# Phase Reference Line

[ESS-0018421](#) PRL in tunnel (envelope)

[ESS-0089756](#) PRL assembly

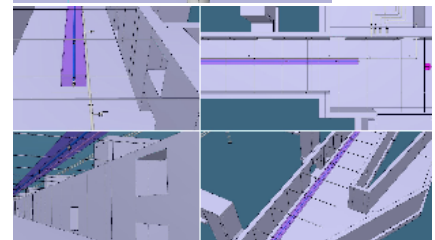
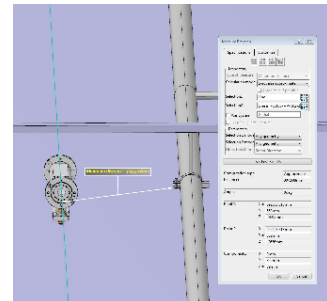
We have prepared a -final version of the PRL design.  
Could you please update the 3D model of the tunnel with our PRL proposal?  
The attached XLS file has new positions of the couplers (column G).  
These positions are coupler center positions.  
The coupler length is 250 mm and you have already received its 3D model in .stp file from Tomasz Lesniak in last days.  
As you know the PRL has thermal insulation all along.  
The couplers + tap points have thermal insulation shell.

We would like to ask you to place the PRL with the new coupler positions into the 3D tunnel model to check for collisions, etc.

Due to thermal expansion of the rigid line which is made of copper, due to tolerance of the components lengths and due to servicing reasons, etc. the PRL needs to have some clearance (in the x-direction along tunnel axis). That is why the coupler+tap points should not be placed in close proximity to other tunnel objects (barriers in the x-direction along tunnel axis). The clearance in y- and z-direction (perpendicular to the tunnel axis) has already been discussed by Wojciech Winieta and Krzysztof Oliva so I think you have got these information.

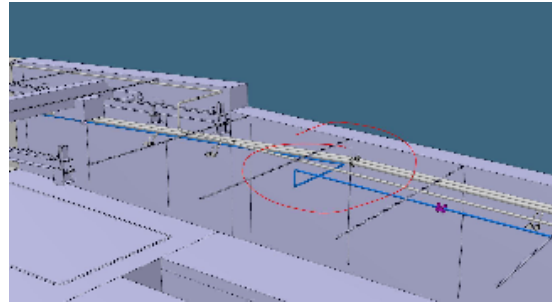
Meeting with IKC and AD (RF + integration + installation) regarding PRL bending in A2T area (because of crane):

- ☐ add PRL to wall as shown in picture (keep both lines...) Carl  
-Johan Hårdh

- flexible bends? could be added later

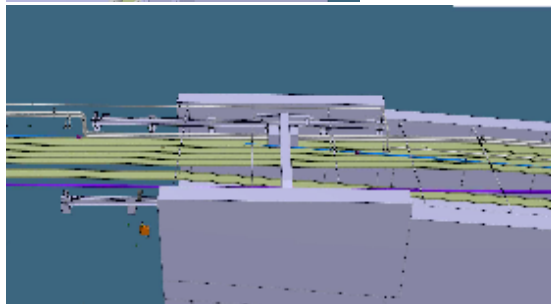
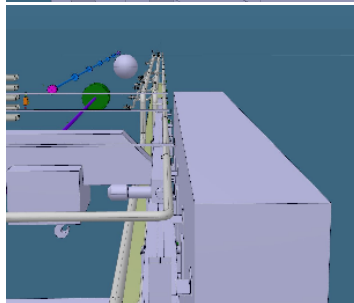
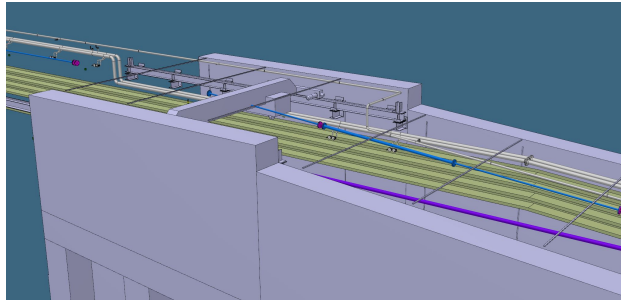
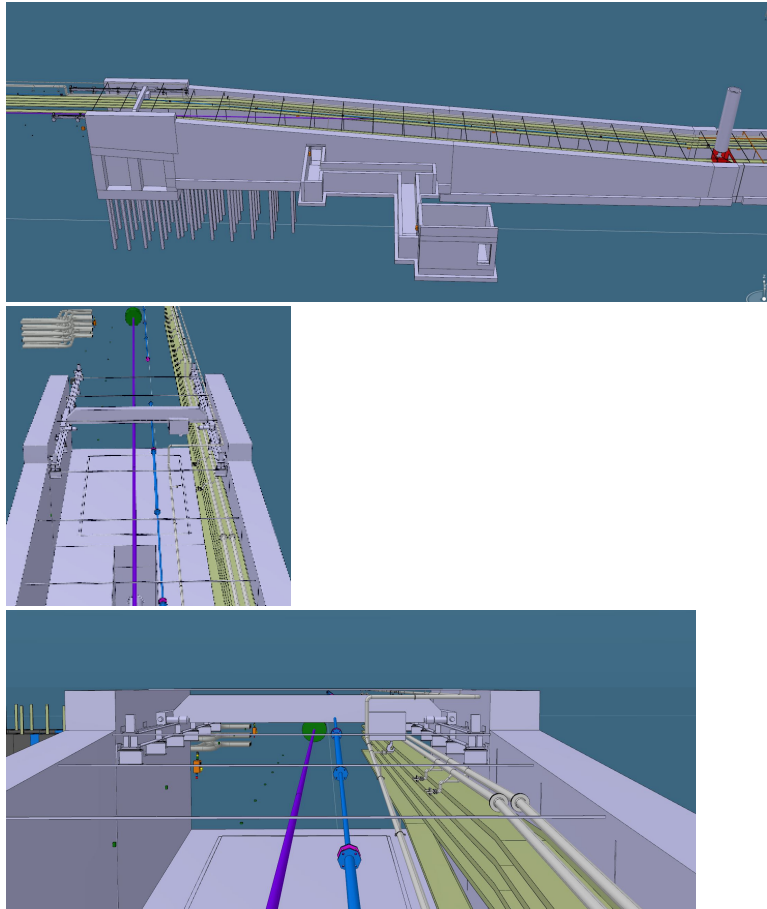
- frame for supporting PRL is very close to roof (30mm), see pdf. Today we have an envelope that is 100mm of free space in roof, is this solution possible?
- PRL might need to be moved closer to south wall due to installation frame and the couplers and cables that will have to be connected as well (very close to instrument air).

- ☒ move it down as well? more space? or will clash with other installations? to be checked!!! Carl-Johan Hårdh

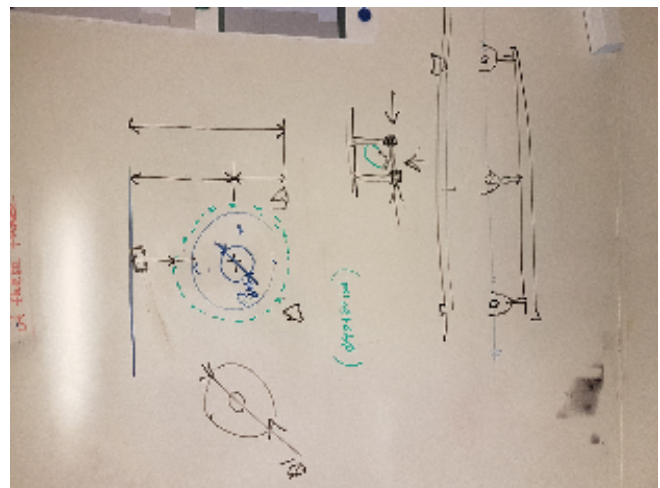
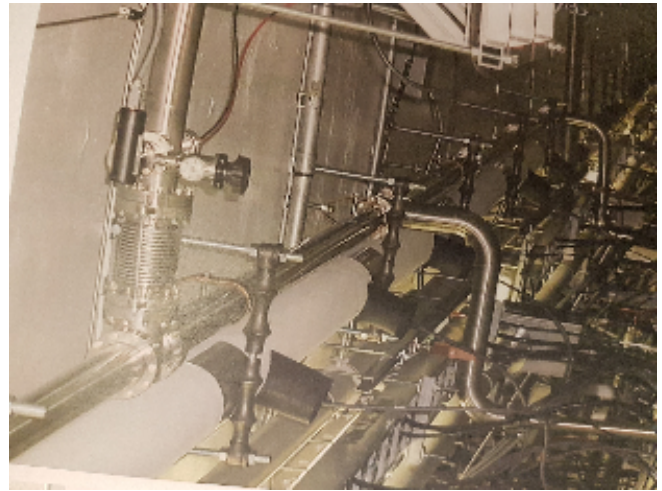
- Use DO=160mm (if 55mm insul is not standard, 160mm = 60mm insul).
- Frame from HAC30 (see picture) as support and "protection"
- Frame from roof every 3m, extra support between (1,5m). Similar to SNS support (see picture) but with extra beam along pipe (for protection and to hold extra support)

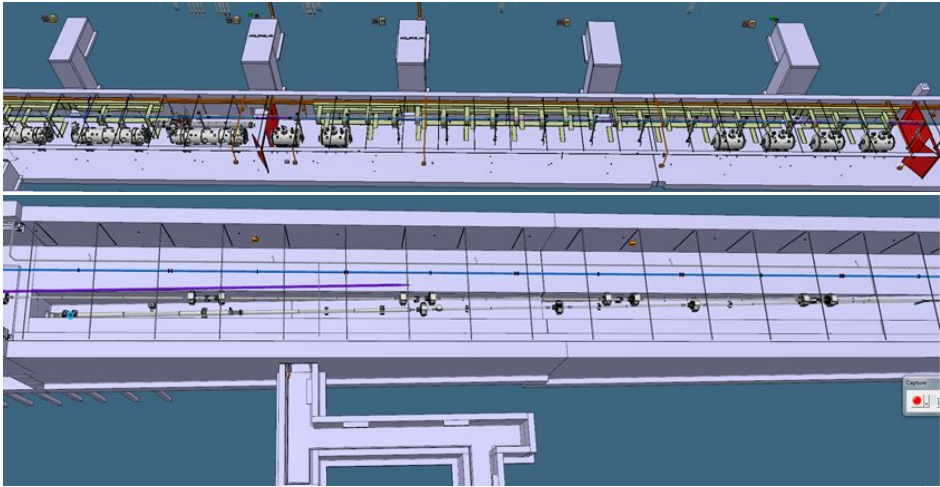
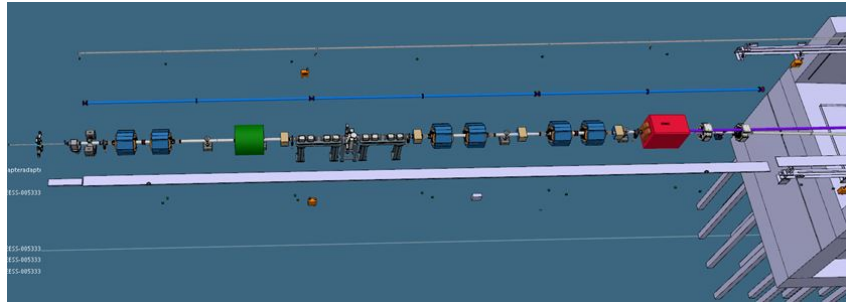
- agreed that PRL can be moved (since it now has grown bigger with insulation)

to make sure we have enough space to roof and instrument air pipe. we foresee minor change of approx 50mm...

✓ move PRL Carl-Johan Hårdh
